UNITED STATES
DEPARTMENT OF THE INTERIOR
BUREAU OF LAND MANAGEMENTFORM APPROVED
OMB NO. 1004-0137
Expires: January 31, 2018**SUNDRY NOTICES AND REPORTS ON WELLS**
*Do not use this form for proposals to drill or to re-enter an abandoned well. Use form 3160-3 (APD) for such proposals.*5. Lease Serial No.
NMLC062300

8. Well Name and No.
CO YETI 15 22 FED COM 0052H9. API Well No.
30-025-45534-00-X110. Field and Pool or Exploratory Area
WOLFCAMP11. County or Parish, State
LEA COUNTY, NM

Changes to APD/COA for Federal Well

Summary of Changes to APD Submission

BLOWOUT PREVENTER SCHEMATIC

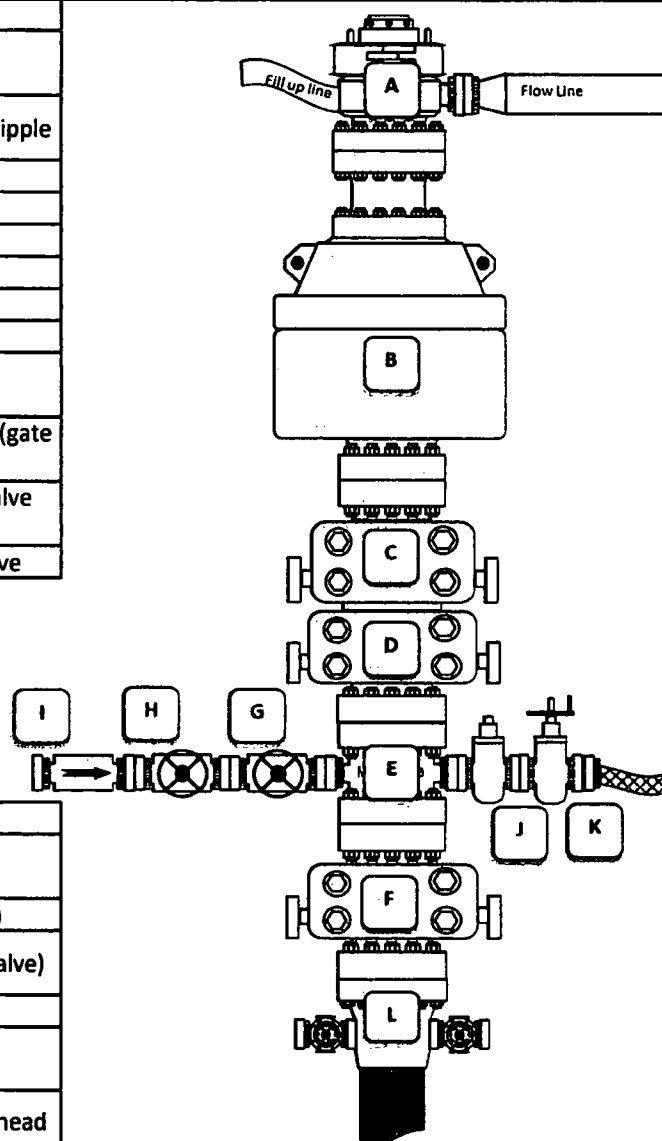
The Class 4 BOP 5M BOP System (with upgraded 10M Stack/Choke manifold) and test pressures shall reflect as follows:

Component	Pressure – Low (PSI)	Pressure – High (PSI)
13 5/8" Annular	250-350	3500
3.5"x 5.5" or 4.5" x 7" VBRs or Rams	250-350	6650
3.5"x 5.5" or 4.5" x 7" VBRs or Rams	250-350	6650
Choke Manifold (valves)	250-350	6650

(Per onshore order 2, the 5M BOP/Choke Manifold Equipment stack will include 1x adjustable choke and 1x remotely operated choke.)
